**Application by National Highways for an Order granting Development Consent for
The Lower Thames Crossing**

**WRITTEN REPRESENTATION ON BEHALF OF
ST. MODWEN DEVELOPMENTS LIMITED
(PLANNING INSPECTORATE REFERENCE:
20035817)**

Figure 7 – LTC B186 Access proposals

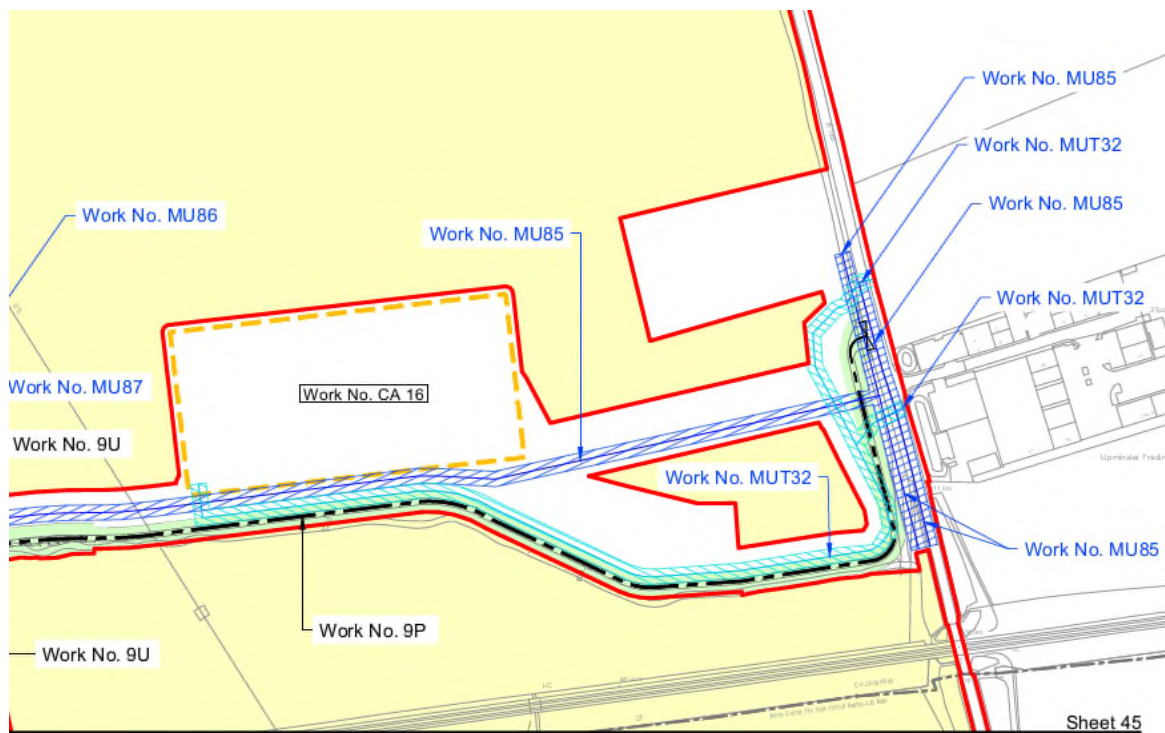
- 10.4 The LTC B186 Access is shown on Sheet 45 of the Works Plans (HE540039-CJV-BOP-SZZ_GN000000_-DR-CX-20043 Rev P01) [APP-020], an extract of which is included at Figure 7 below:

- 10.5 There is a significant risk that the delivery of both the LTC B186 Access and the BEP B186 Access would be unacceptable to ECC on highway safety grounds, due to the close proximity of the two accesses.

- 10.6 Furthermore, SMDL has concerns regarding the safety of the LTC B186 Access in any event. The Applicant proposes a simple give-way junction off the B186 that will provide vehicular access for a temporary compound during construction and for infrequent use by maintenance vehicles once LTC is operational. SMDL understands that the Applicant's intention is that during the construction of LTC, access will be managed by traffic marshals/banksmen. Nonetheless, there remain road safety concerns regarding the proposed location of the LTC access on the B186 due to its proximity to the 'humpback' bridge over the railway to the south that will severely restrict visibility between northbound vehicles on the B186 and any LTC construction vehicles accessing the site, particularly as the B186 in this location is subject to the national speed limit, which is 60mph for cars and light goods vehicles.

Figure 8 – LTC Compulsory Acquisition proposals

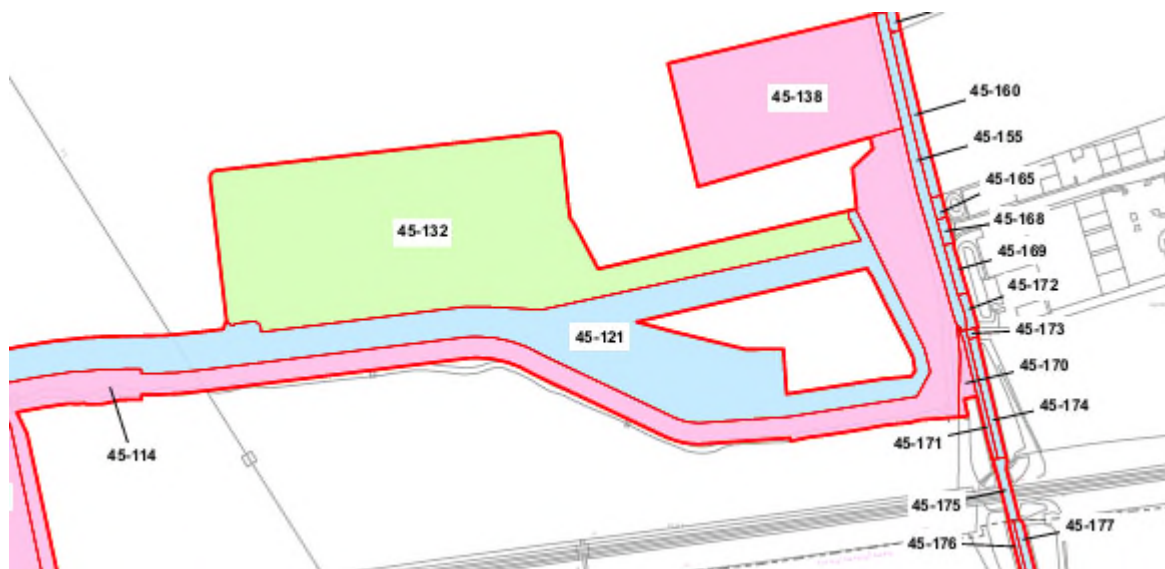
10.11 Furthermore, the Land Plans submitted as part of the LTC application show that the Applicant seeks the power to permanently acquire the land that is required for the BEP B186 Access – see the area shaded pink and marked ‘45-138’ and ‘45-114’ on Figure 8 below (which is an extract from Sheet 45 of the Land Plans (reference HE450039-CJV-BOP-ZZZ_BD000000_-DR-BL-20045 Rev P01) [APP-008]:

10.12 SMDL’s position is that the draft DCO as currently proposed would have a fundamentally unacceptable impact upon the BEP site and SMDL/Padfield’s interests for the following key reasons:

- 10.12.1 The DCO would provide the Applicant with the power to permanently acquire the land required for the BEP B186 Access and associated visibility splays (plots 45-138 and 45-114). This would sever an essential access to BEP and would effectively sterilise the site for any meaningful development. Even if the Applicant does not actually intend to permanently acquire the land, the mere existence of the power would cause significant uncertainty around the delivery and future operations of the BEP. In any event, it is unclear why the Applicant requires the power to compulsorily acquire this land given that the Applicant's own position, as set out in the Design Principles, is that the LTC works would only utilise this land in the event that the BEP B186 Access has been delivered – in such circumstances, it would be entirely inappropriate for the Applicant to acquire the land.

Figure 9 – LTC A127 Bridge

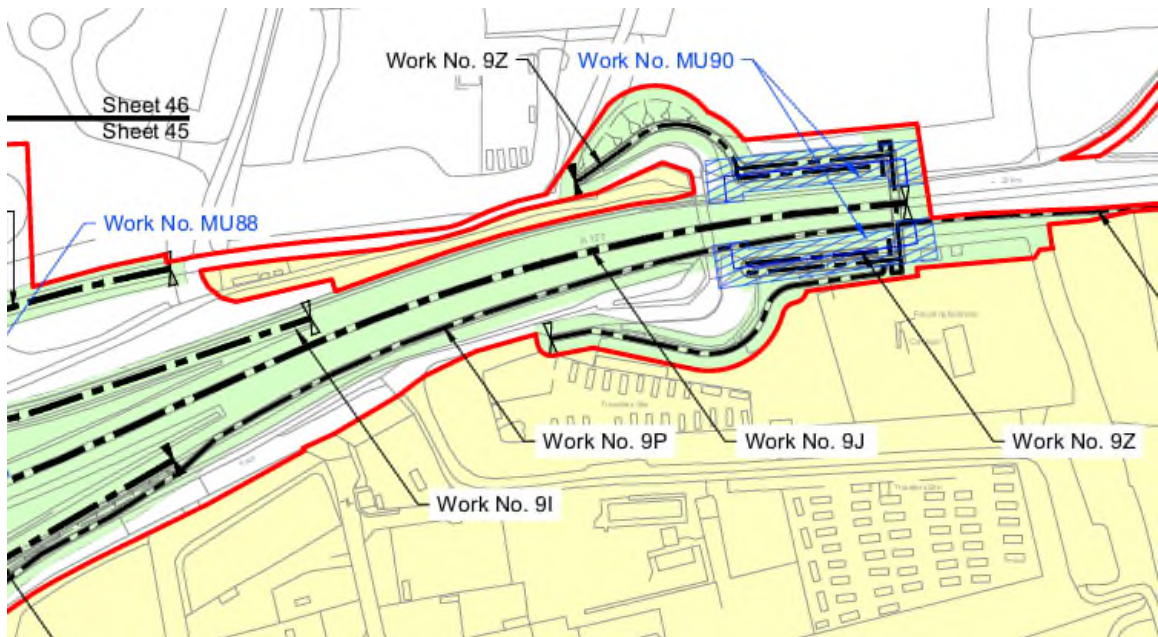
- 11.2 Through the development of the LTC proposals, SMDL understands that the Applicant reached a conclusion that it was necessary to find a way to enable WCHs to cross from the south side of the A127 to the north side (and vice versa). This requirement resulted from LTC's proposed dedicated free-flow lanes from the A127 westbound to the M25 southbound and from the M25 northbound to the A127 westbound which will sever the existing WCH route along the south side of the A127. In order to address this, the Applicant has included a new WCH bridge as shown marked 'Work No. 9Z' on Figure 9 below (extracted from Sheet 45 of the Works Plans (reference HE540039-CJV-BOP-SZZ_GN000000_-DR-CX-20043 Rev P01) [APP-020] (the "**LTC A127 Bridge**")):

- 11.4 As will be readily apparent from a comparison of the LTC plans with the BEP plans, the LTC A127 Bridge is fundamentally incompatible with the BEP A127 Bridge. This is acknowledged by the Applicant at paragraph 6.8.13 of the Interrelationship Statement [APP-550]. The LTC A127 Bridge is located in the same location as the BEP A127 Bridge and will render it impossible for the BEP A127 Bridge to be delivered for as long as the LTC A127 Bridge remains in situ. Furthermore, the proposed compulsory acquisition of land would again make it impossible for SMDL to deliver the BEP A127 Bridge, thereby severing one of the two vehicular accesses to the BEP (the BEP B186 Access being the other).
- 11.5 There has again been constructive dialogue between SMDL and the Applicant in this regard. As noted at paragraphs 6.8.14-6.8.16 of the Interrelationship Statement, it has been agreed in principle

Figure 10 – Proposed Permanent Acquisition of Land at A127

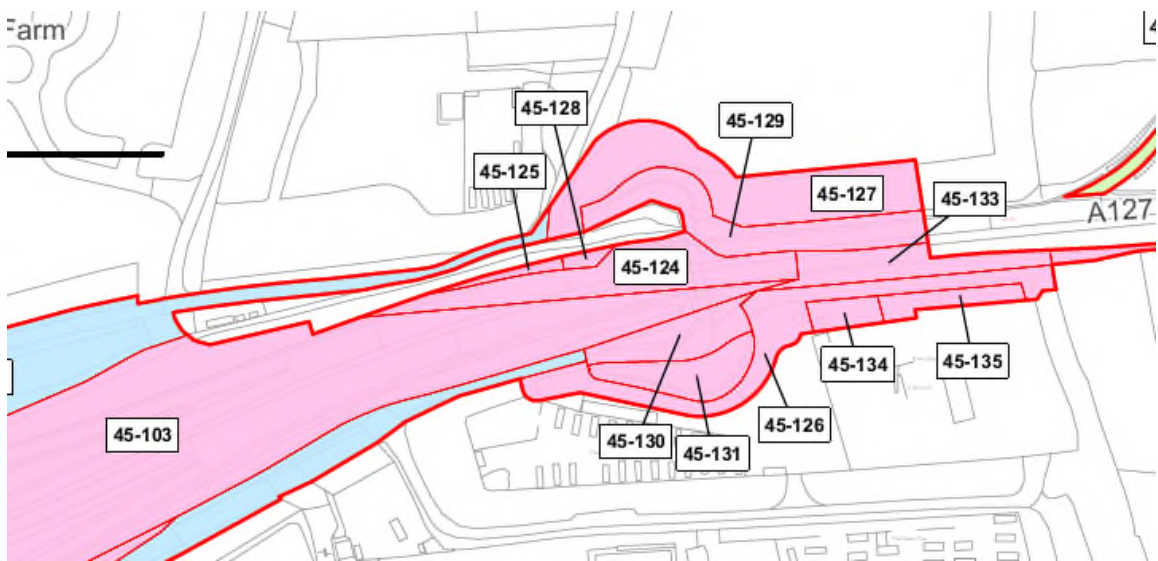
- 11.3 The Applicant has further proposed a significant amount of permanent land acquisition in this location, as shown shaded pink on Figure 10 below (extracted from Sheet 45 of the Land Plans (reference HE450039-CJV-BOP-ZZZ_BD000000_-DR-BL-20045 Rev P01 [APP-008]):

11.7.1 The DCO would provide the Applicant with the power to permanently acquire the land required for the BEP A127 Bridge. This would sever an essential access to BEP and would effectively sterilise the site for any meaningful development. Even if the Applicant does not actually intend to permanently acquire the land, the mere existence of the power would cause significant uncertainty around the delivery and future operations of the BEP.

Figure 11 – Codham Hall Lane Proposed Land Acquisition

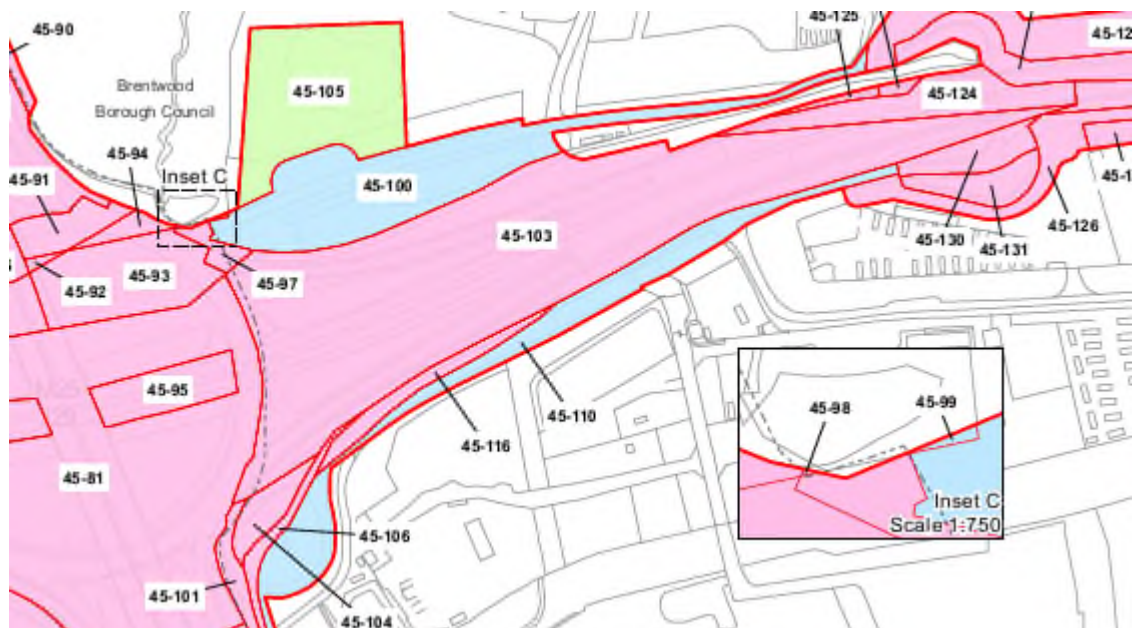
- 12.1 As explained above, the access arrangements to the BEP site will utilise the existing Codham Hall Lane to the north of the A127. However, it is noted that the Applicant proposes to take temporary possession of Codham Hall Lane and acquire permanent rights over it. This land is shaded blue and identified as plots 45-99 and 45-100 on Figure 11 below (extracted from Sheet 45 of the Land Plans (reference HE450039-CJV-BOP-ZZZ_BD000000_-DR-BL-20045 Rev P01 [APP-008]):

- 12.2 SMDL is concerned that no explanation has been provided by the Applicant for why temporary possession of this land is required, when it will be required, and for how long. This land is a fundamental part of the access arrangements for BEP (not to mention the existing uses at Codham Hall North and Codham Hall South) and so it is essential that it is kept open at all times.

- 12.4 This land has not formed part of the previous discussions between SMDL and the Applicant and it is noted that the Interrelationship Statement does not explain the impact of this part of the LTC proposal on BEP. It is assumed that the land is included in order to provide the Applicant with flexibility around
